APPEAL SUMMARY

<b>Appeal ID:</b> 24633	<b>Project Address:</b> 801 SW 10th Ave
<b>Hearing Date:</b> 2/24/21	<b>Appellant Name:</b> Tereza Wiest
<b>Case No.:</b> B-001	<b>Appellant Phone:</b> 503-542-3016
<b>Appeal Type:</b> Building	<b>Plans Examiner/Inspector:</b> Steve Freeh
<b>Project Type:</b> commercial	<b>Stories:</b> 7 <b>Occupancy:</b> A-3 <b>Construction Type:</b> 1-A
<b>Building/Business Name:</b> Multnomah County Library - Central Library	<b>Fire Sprinklers:</b> Yes -
<b>Appeal Involves:</b> Alteration of an existing structure, Addition to an existing structure	
<b>Plan Submitted Option:</b> pdf [File 1]	<b>Proposed use:</b> Public Library

Appeal item 1

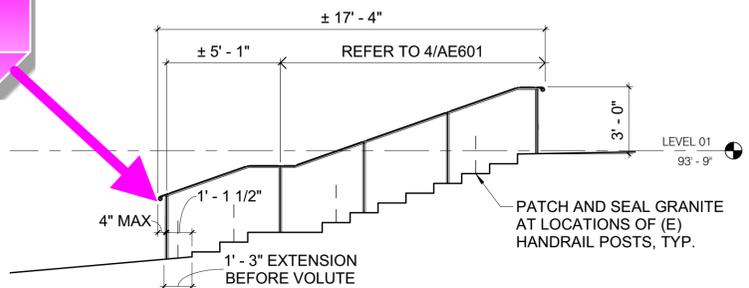
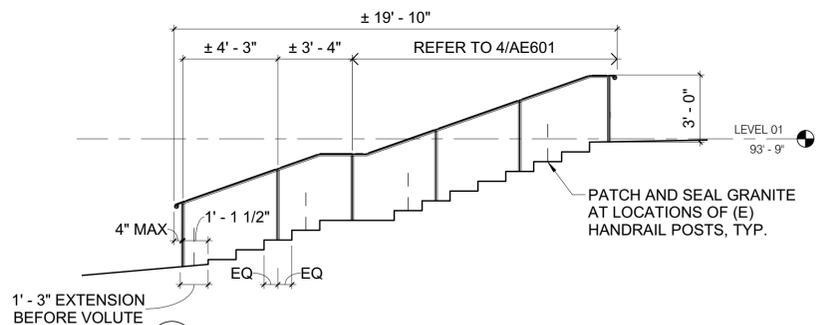
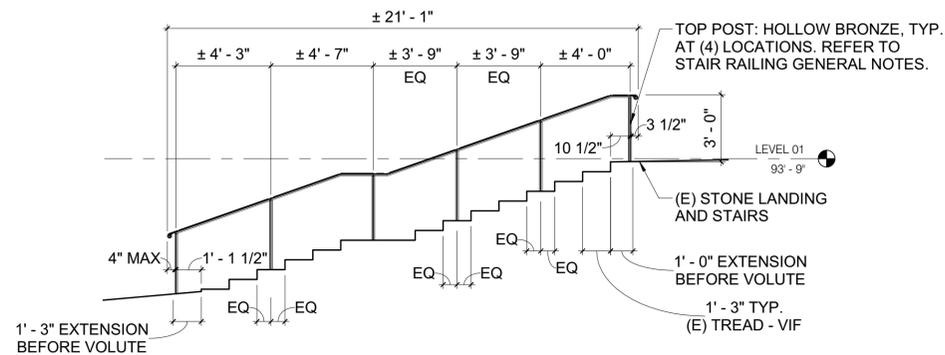
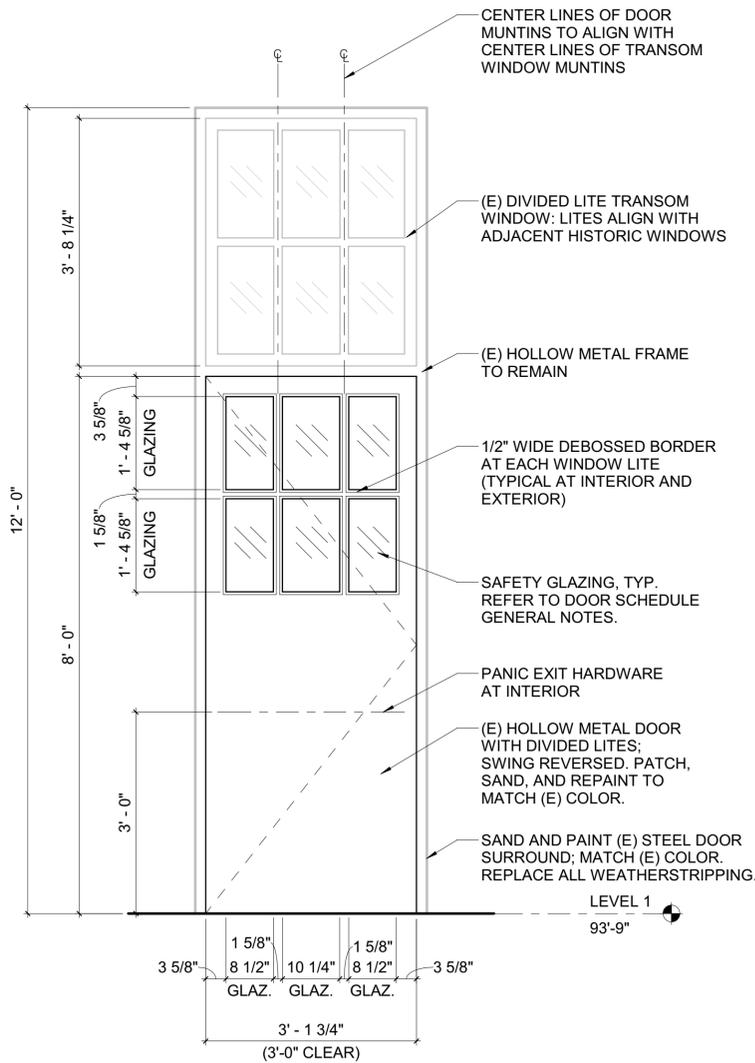
<b>Code Section</b>	OSSC 2019 1014.6, Handrail Extensions
<b>Requires</b>	Handrails shall return to a wall, guard, or walking surface or shall be continuous to the handrail of an adjacent flight.
<b>Code Modification or Alternate Requested</b>	We request that volute terminations be allowed at stair handrails in lieu of the handrails returning to a wall, guard, or walking surface.
<b>Proposed Design</b>	Bronze volute terminations with an extension of 4" or less beyond the support posts below are proposed at the top and bottom of each length of new handrail. The handrail extensions required by OSSC 2019 1014.6 will be maintained.
<b>Reason for alternative</b>	<p>This alternate is proposed in order to allude to the design of the existing bronze handrails that will be replaced at the Library's main stair and to integrate the new railing design with the historic architecture of the building, which is listed on the National Register of Historic Places. The proposed railing design evolved through the Historic Resources Review process (LU 20-175630 HR) because of the importance of this historic sensitivity.</p> <p>The volute terminations extend beyond the required lengths of the handrail extensions and will not interrupt the code-required gripping surface. Accessibility will be improved from the existing conditions, in which the handrails at the main entrance stair do not meet the extension and continuity requirements of current code. Since the volutes will not extend by greater than 4" beyond the posts below, they will not be hazardous projections. The proposed design complies with the intent of the code.</p>

**Use of volute terminations at stair handrails in lieu of the handrails returning to a wall, guard, or walking surface: Granted as proposed.**
